## ADDENDUM

ADDENDUM NO. **ONE**  
PROJECT TITLE: **Tawny Oaks Site Development**

ISSUANCE DATE: May 29, 2014

1 Conventional Concrete - Walk

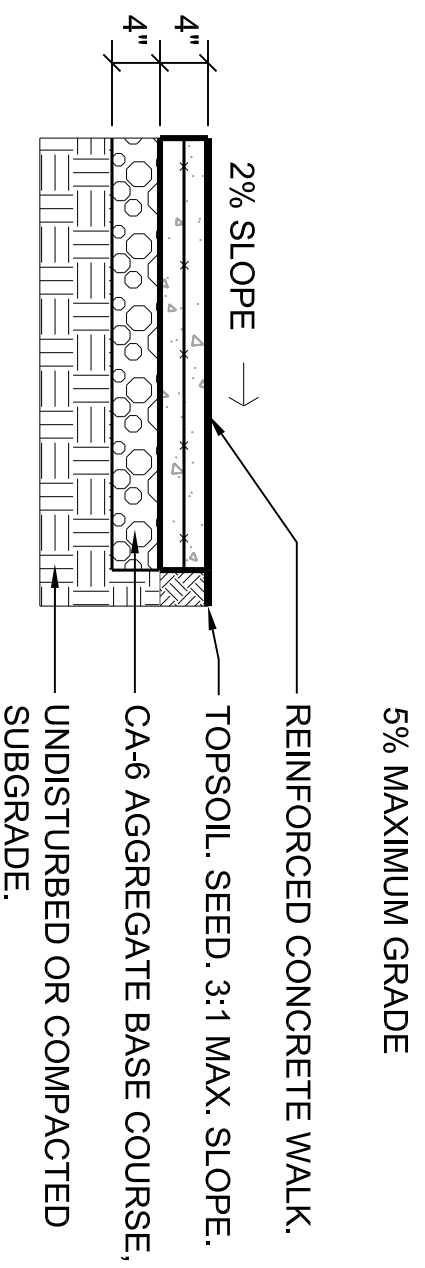
- I. **DRAWINGS:**
  - a. Replace Detail 1 on Sheet 6 with the attached Detail 1B. On Sheet 3, Site Plan, under sidewalk heading, change 'See detail 1/6' to 'See detail 1/6B'.
